**City Planning Commission  
Meeting – March 10, 2015**

**CONSIDERATION – SUBDIVISION DOCKET – 008-15  
Applicant: Arthur Neville, Lorraine Neville**

**Proposal:** Re-Subdivision of Lots 25-B and 26-C into Lots 25B1 and 25C1.

**Figure 1: Historic Sanborn Maps**

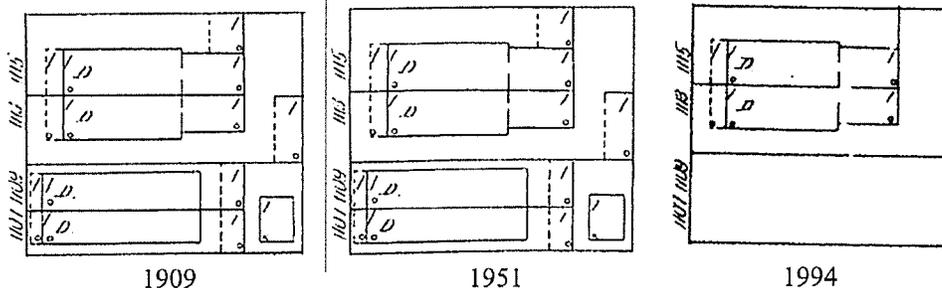
The request meets Criterion C. 1113-1115 Valence Street was constructed by 1909, as shown on that year's Sanborn map. The map indicates that the structure was originally constructed as a two-family residence. Sometime after 1994, the structure was converted to a single-family residence and an addition was added on the Coliseum Street side. 1107-1109 Valence Street was formerly occupied by a two-family residence which was constructed sometime before 1909. The structure was demolished sometime between 1951 and 1994.

A Resubdivision of Lots 25-B & 26-C into Lots 25B1 & 26C1.

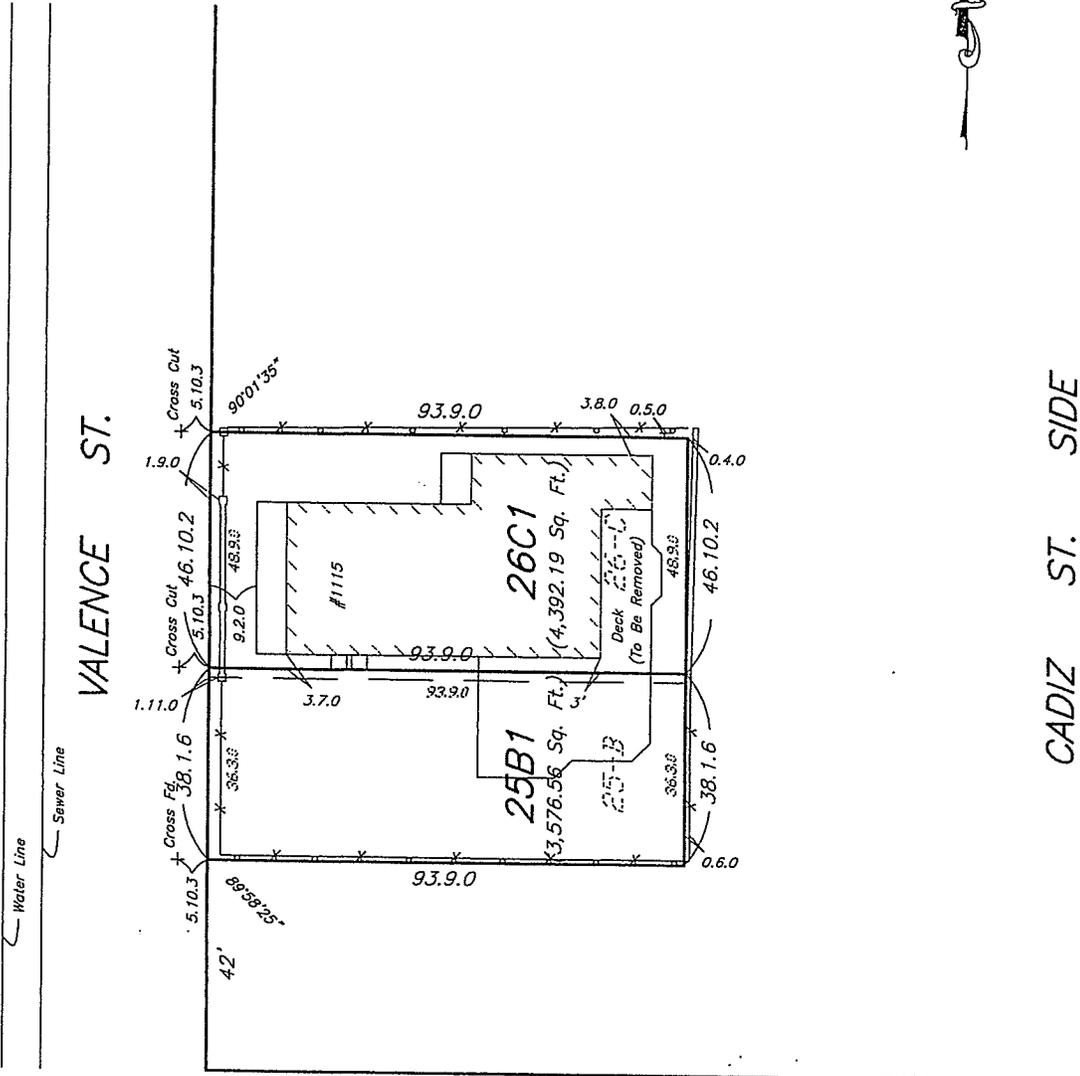
The request does not satisfy criteria a. **Article 4, Section 4.5.7, (Table 4.E)** of the *Comprehensive Zoning Ordinance* requires a minimum lot area of four thousand four hundred square feet (4,400 sq. ft.) for single-family residences. Both proposed lots do not meet this requirement. The lot area for existing Lot 26-C would be reduced below the minimum lot size required by the *Comprehensive Zoning Ordinance*.

In addition, the proposal would slightly decrease the aggregate side yard width of the existing residence. **Article 4, Section 4.5.7, (Table 4.E)** requires that the aggregate width of side yards measure at least twenty percent (20%) of actual lot width. The existing Lot 26-C is required to have a minimum aggregate side yard width of nine feet, nine inches (9' - 9"), it currently provides eight feet, seven inches (8' - 7") or approximately seventeen and six tenths percent (17.6%) of actual lot width. The proposed subdivision would slightly decrease the lot width, and as a result the proposed Lot 26C1 would have a slightly smaller minimum aggregate side yard width requirement of nine feet, four inches (9' - 4"). The proposed subdivision would provide an aggregate side yard width of approximately six feet, eight inches (6' - 8") or roughly fourteen and two tenths percent (14.2%) of actual lot width, which is less compliant than the existing aggregate side yard width.

The increased compliance with the requirements of the district for Lot 25B1 would be off-set by the loss of conformity in relation to lot area for Lot 26C1 and the increased nonconformity of aggregate side yard width. As such, it does not meet Criterion B.

In addition, the proposed subdivision would decrease the aggregate side yard width of the existing residence at 1115 Valence Street. **Article 4, Section 4.5.7, (Table 4.E)** requires that the aggregate width of side yards measure at least twenty percent (20%) of actual lot width. While the current lot only provides approximately seventeen and six tenths percent (17.6%) of actual lot width, the proposed subdivision would reduce the aggregate side yard width to roughly fourteen and two tenths percent (14.2%) of actual lot width.

- The applicant shall apply for and obtain a variance from the Board of Zoning Adjustments for any necessary waivers, including minimum lot width and area for proposed Lot 25B1 and minimum lot area and aggregate side yard width for proposed Lot 26C1.

The staff recommends **denial** of Subdivision Docket 008-15.
